MORKRUM MULTIPLEX PRINTING TELEGRAPH SYSTEM

This supplement forms a part of specification 111 and 112, all issues to date, and covers changes in the Main Line Relay Tongue Circuit and Main Line Relay Vibrating Circuit.

THEORY OF NEW CIRCUITS

FIGURE 1

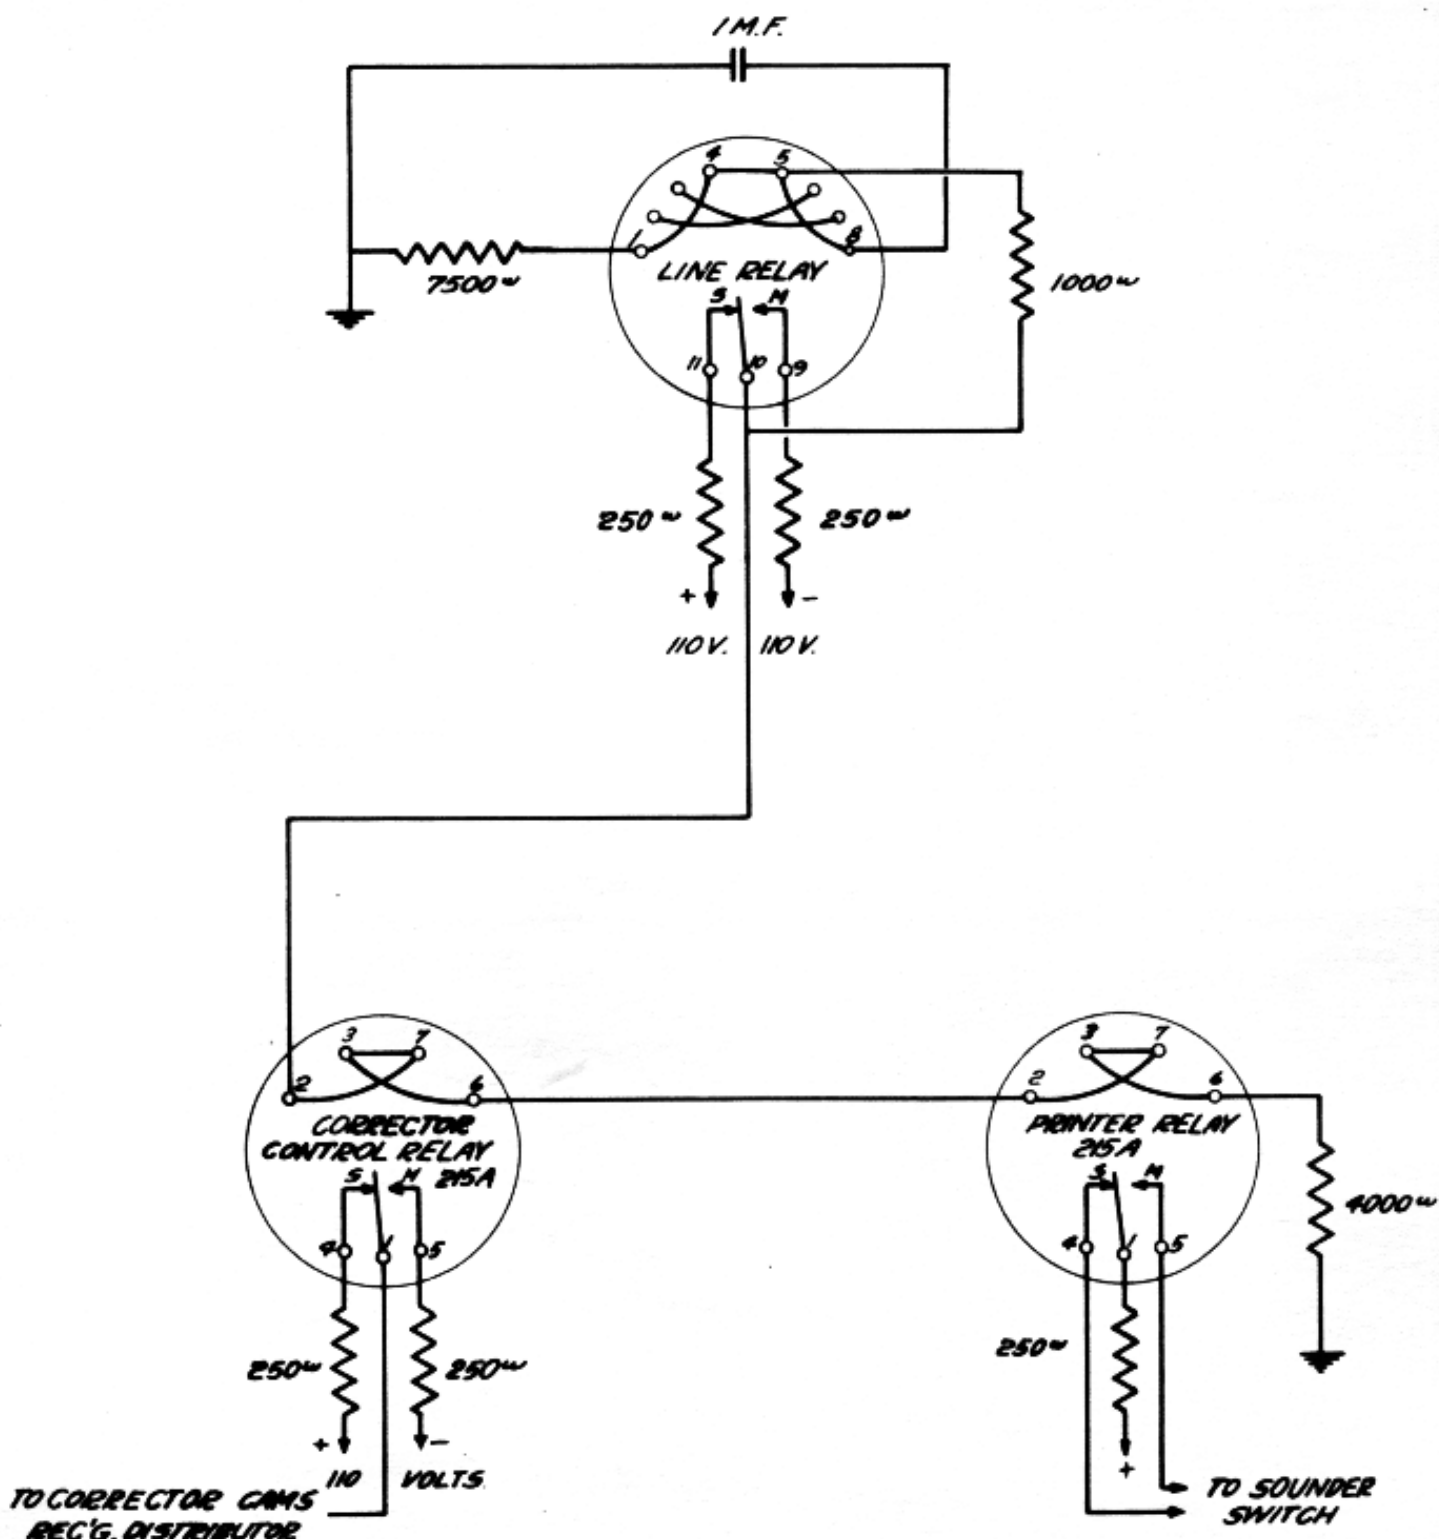
In the old main line relay circuit, see Fig. 1, the main line relay tongue is connected directly to the printer relay coils and at the same time to the corrector cam contacts. The latter fact makes the current through the printer relay coils vary under different conditions of the corrector circuit, owing to the diversion of the impulses from the main line relay tongue.

In the new circuit an additional relay is introduced, called the Corrector Control Relay. The coils of this relay are in series with the printer relay coils and are connected so that its armature movement corresponds with the armature movement of the main line relay. Its contacts are connected to plus and minus 110 volts local battery respectively and the tongue to the corrector cam contacts. Thus, the corrector cam contacts are connected to plus or minus battery, depending upon which contact the line relay and the corrector control relay tongue is resting. With the corrector cam circuits removed from the main line relay tongue, the current through the new corrector control relay and printer relay coil does not vary and the result is a steadier action of the correction and selecting circuits.

FIGURE 2

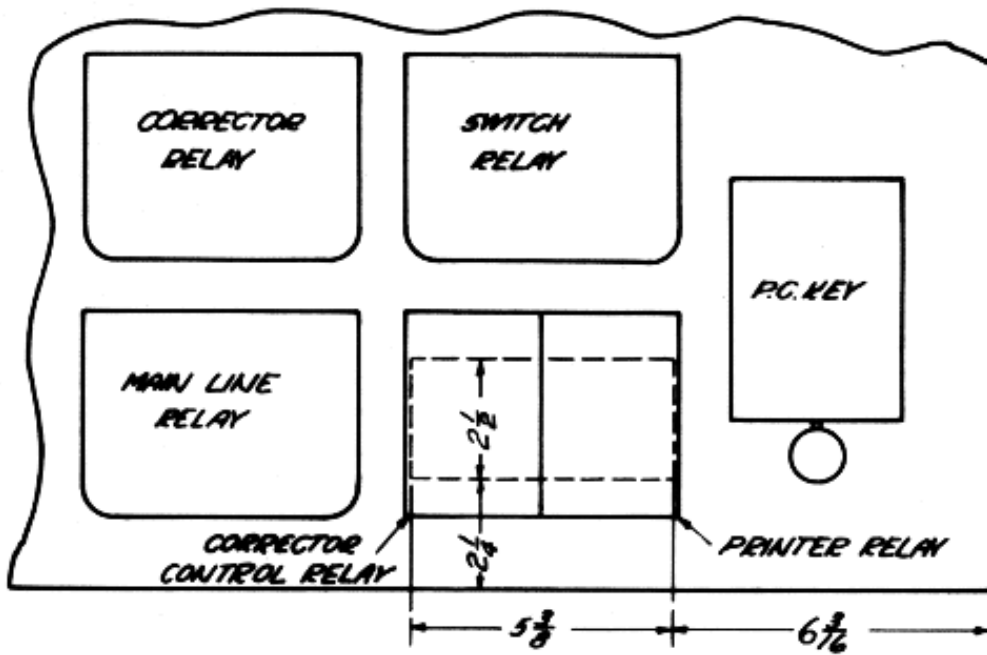
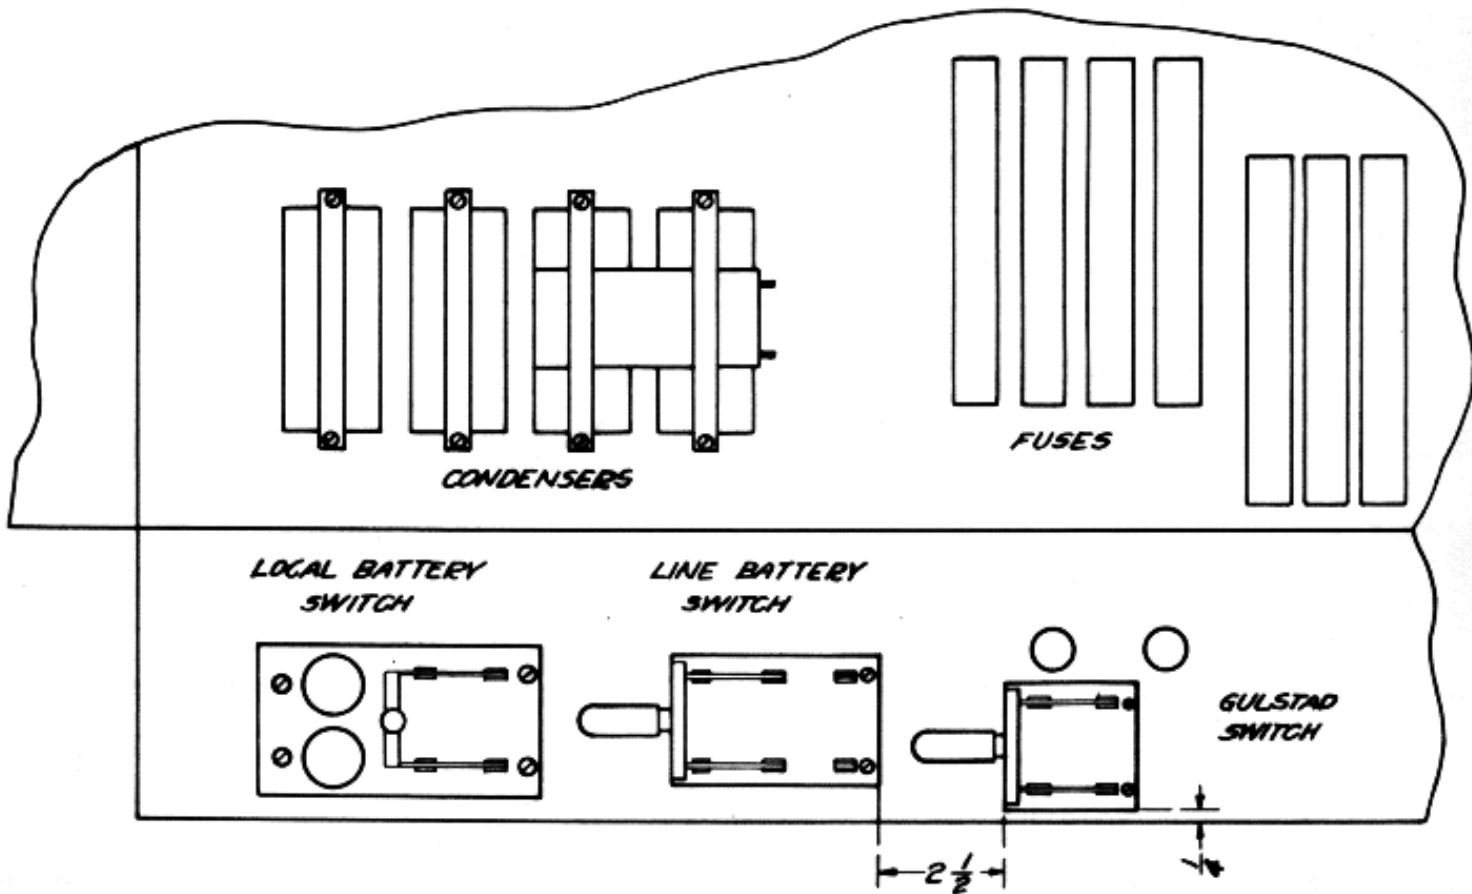
Take off the slip connection frame of the present printer relay and cut table top as shown in Fig. 2 and fit in mounting plates and connection blocks for two RY20 relays as shown.

Mount one #4165 double pole single throw knife switch, called Gulstad Switch, in the panel box as shown in Figure 2.

NOTE:
 CUT TABLE TOP
 AS SHOWN IN DOTTED LINES
 FOR MOUNTING TWO #682B
 MOUNTING PLATES AND
 TWO #6827 CONNECTING
 BLOCKS.

FIGURE 3

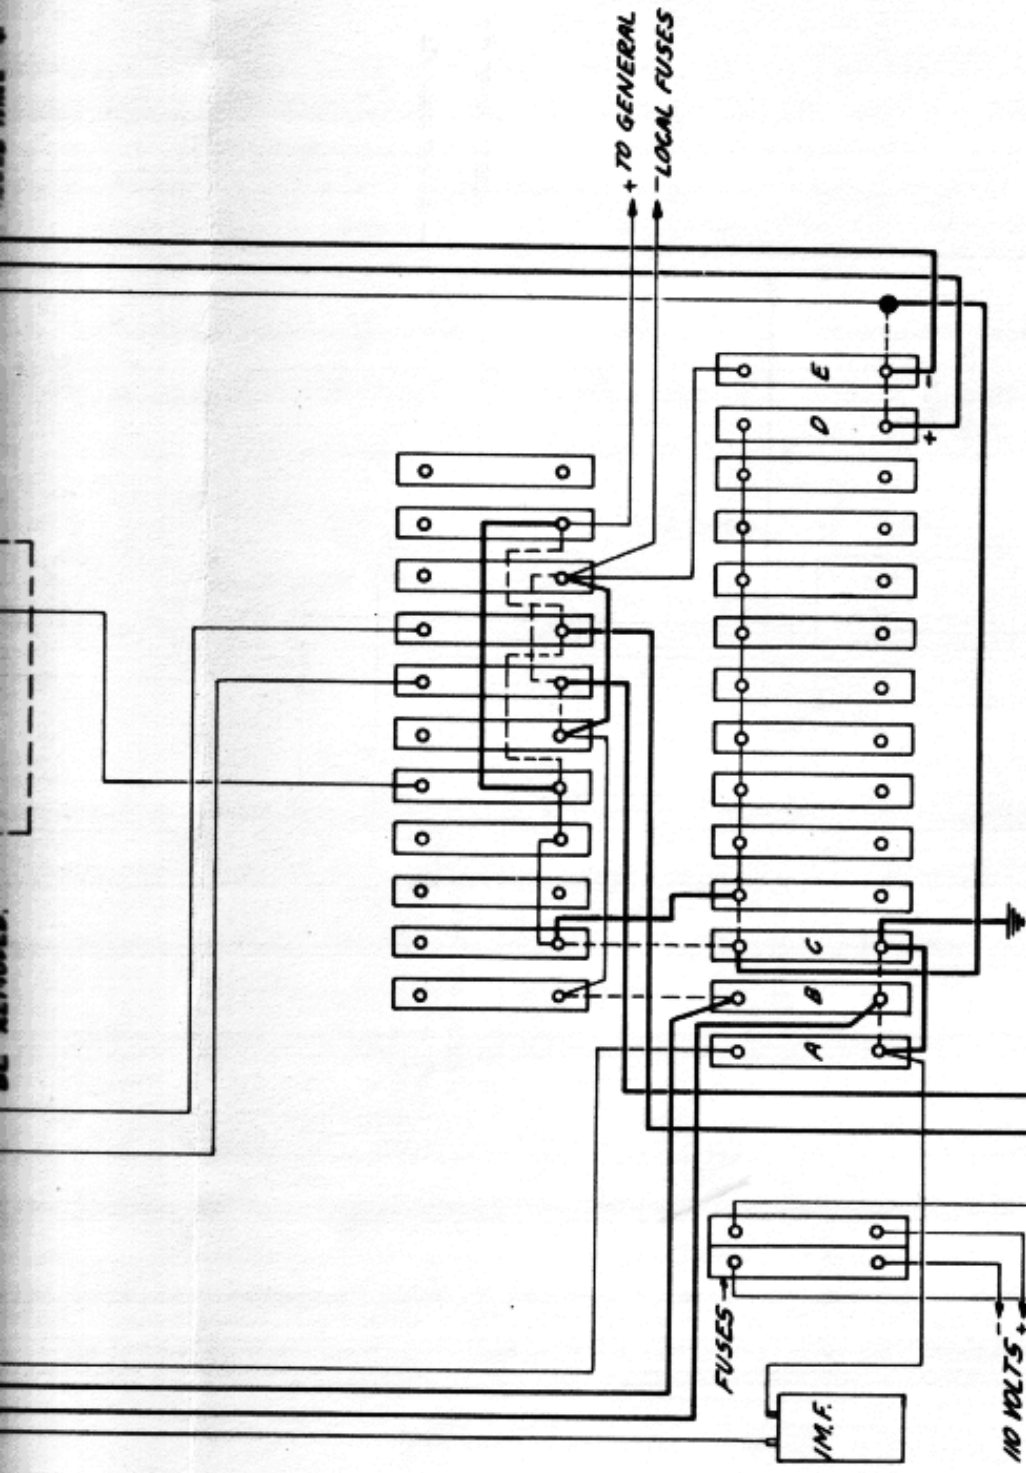
Remove strap that runs from lower terminal of the right hand resistance marked "250 Ohms Line Relay Contact" to both the resistance marked "800 Ohms Corrector Coil" and the resistance marked "250 Ohms Printer Relay Tongue". Also remove strap that runs from lower terminal of the left hand resistance marked "250 Ohms Line Relay Contact" to both the resistance marked "1000 Ohms Sounder" and the resistance marked "1500 Ohms Holding Relay Winding". Add strap between lower terminals of resistance marked "1500 Ohms Holding Relay Winding" and resistance marked "1000 Ohms Sounder". Add strap between lower terminals of resistance marked "250 Ohms Printer Relay Tongue" and resistance marked "800 Ohms Corrector Coil". See Figure 3.

Connect "Added Wire #1" to upper terminal and "Added Wire #2" to lower terminal of left hand block (marked "B" - Figure 3). Remove present 1500 ohms resistance and replace with 1000 ohms. Mark this block "1000 Ohms Line Relay Tongue".

Remove strap between lower terminals of resistances marked "3000 Ohms Printer Relay". Remove wire from lower terminal of right hand block and splice on a sufficient length to connect to upper terminal of present right hand resistance "1500 Ohms Line Relay (marked "C" - Figure 3). Remove the 1500 ohms resistance and replace with 4000 ohms, changing designation to read "4000 Ohms Secondary Relays".

IN POSITIONS A, B, C, D, E, REPLACE PRESENT RESISTANCES
 AND CHANGE DESIGNATIONS AS FOLLOWS:

- A = 7500 OHMS LINE RELAY.
 - B = 1000 OHMS LINE RELAY TONGUE.
 - C = 4000 OHMS SECONDARY RELAYS.
 - D = 250 OHMS CORRECTOR CONTROL RELAY.
 - E = 250 OHMS CORRECTOR CONTROL RELAY.
- THE 4000 OHMS RESISTANCE REMOVED FROM
 POSITION "A" MAY BE USED IN POSITION "C".

WIRING DIAGRAM

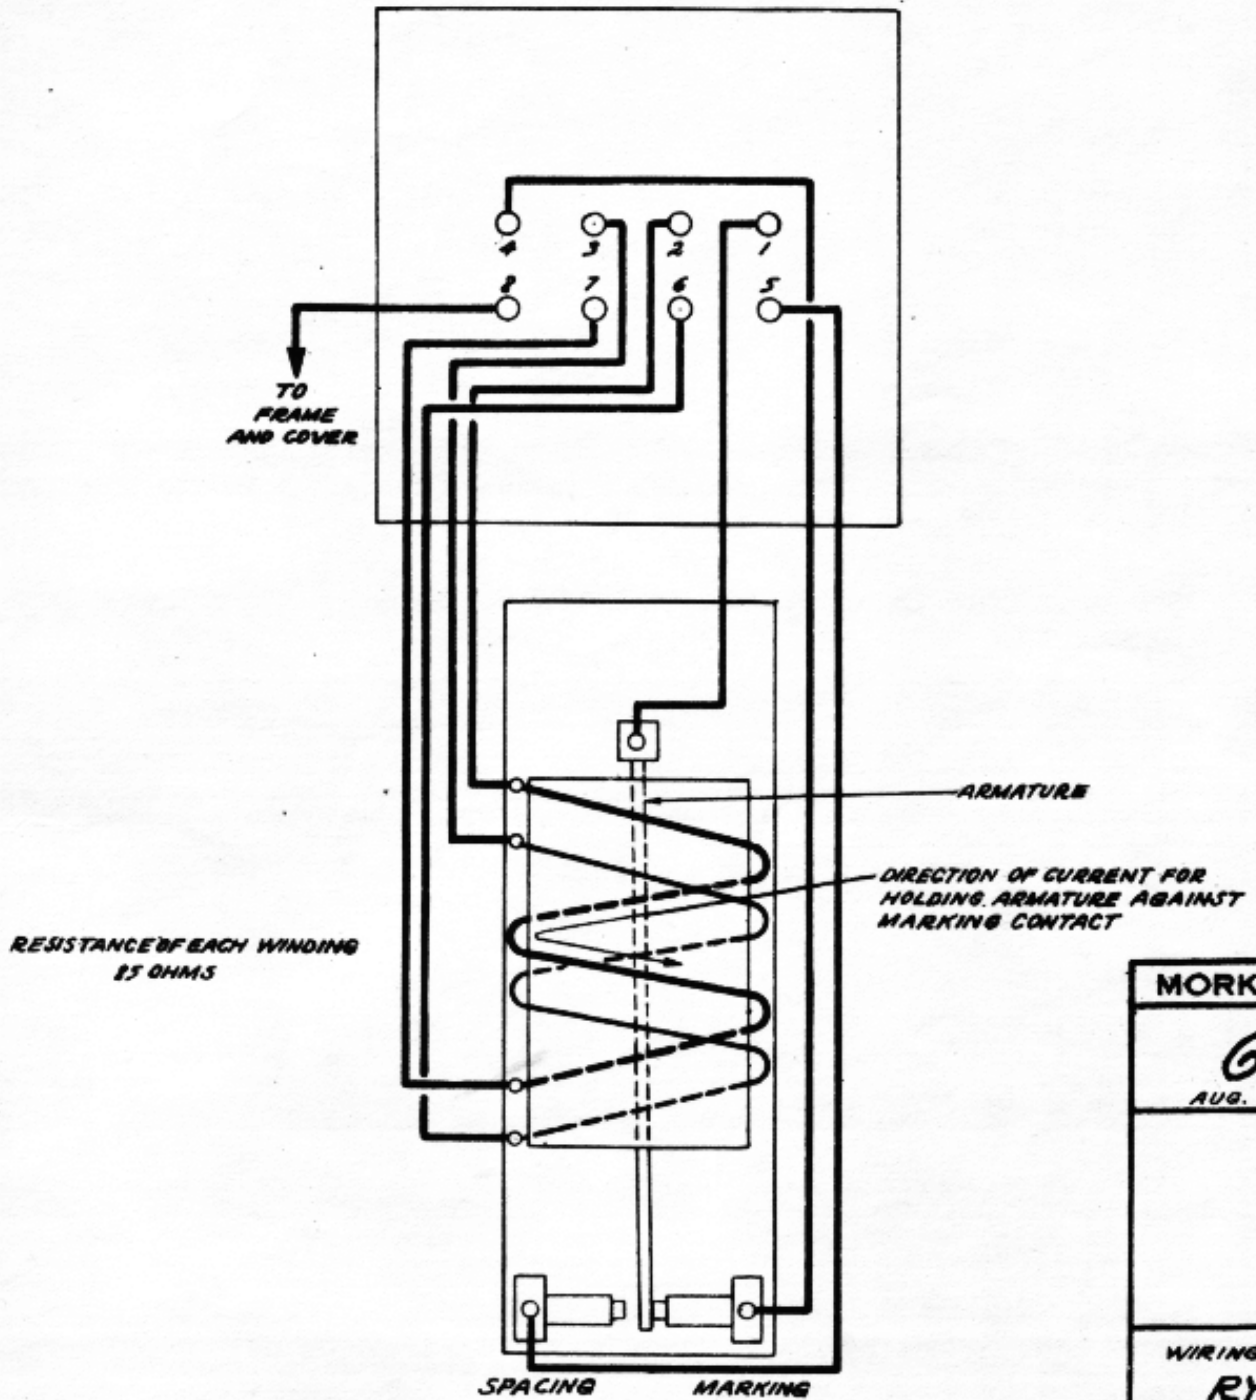
The added RY20 relays are mounted in a vertical position with connecting block reversed from that shown in W.D. #610. In order to make the direction of operation uniform with other relays of the set the contact connected to terminal 4 of the relay is designated the spacing contact and that connected to terminal 5 the marking contact. Reference to the direction of tongue movement in W.D. #610 would then read "against spacing contact" instead of "against marking contact" as indicated.
